A Required Steering Control Effort to override the directional control of

O Republic Of Korea would like to provide ACSF IWG with those data to decide a appropriate steering control effort to override the direction control of ESF&C1

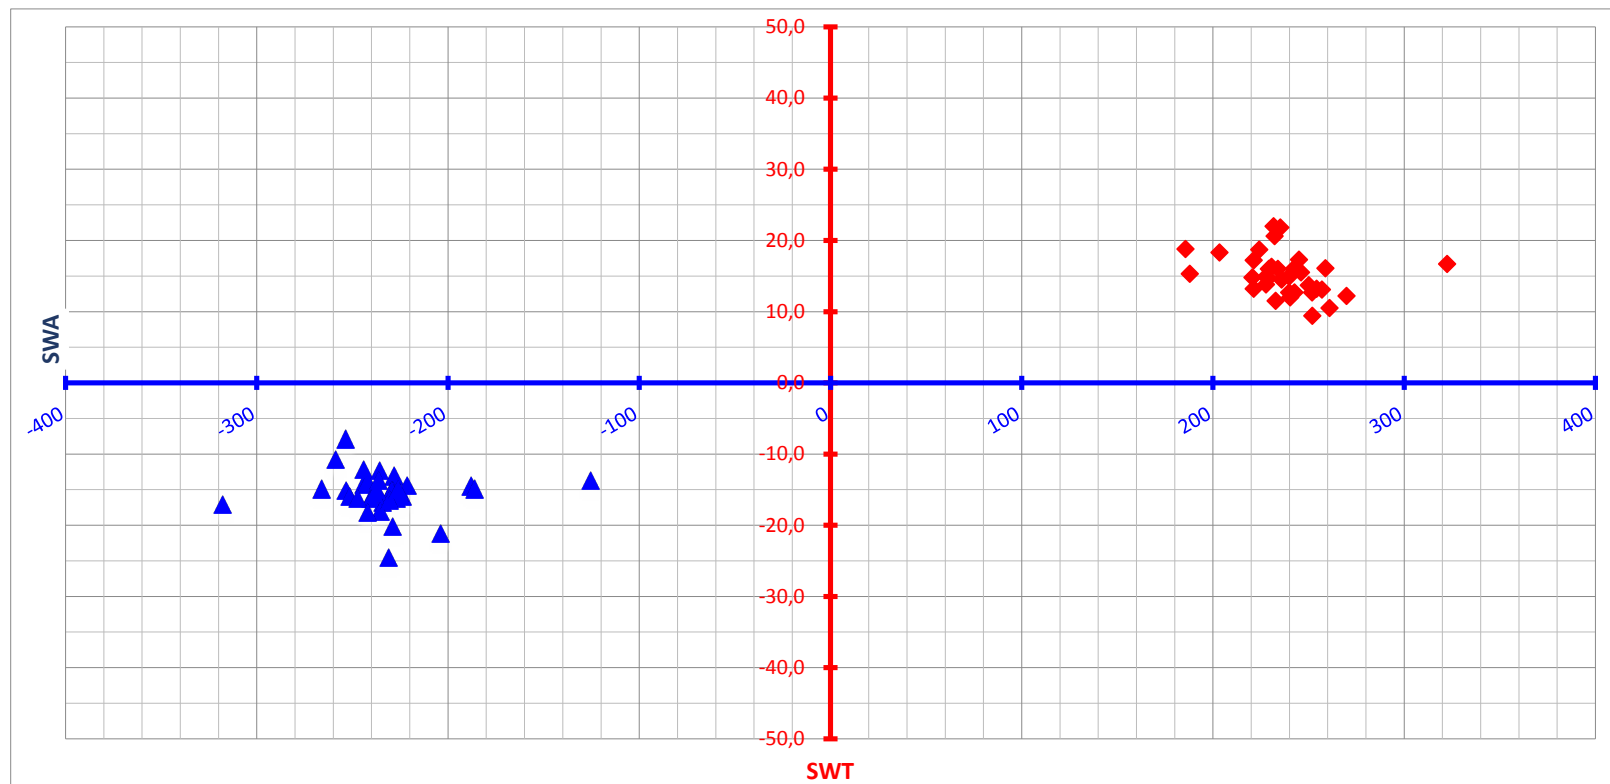
O The below data were the measurement values of compliance test whether Vehicles with Electric Power Steering comply with steering control effort's requirement of KMVSS(harmonized with UN R79(The measurement values of steering efforts on motor vehicles with intact steering equipment)) or not from Y 2013 to Y2016

O As you see the data, 50N already proposed is too high. So we need a appropriate value.

O Therefore, Republic of Korea'd like to propose "30N" as a appropriate value, adding design margin(5N) to Max. of Steering Control Effort(25N)

- "The steering control effort necessary to override the directional control provided by the system shall not exceed [5030N]"
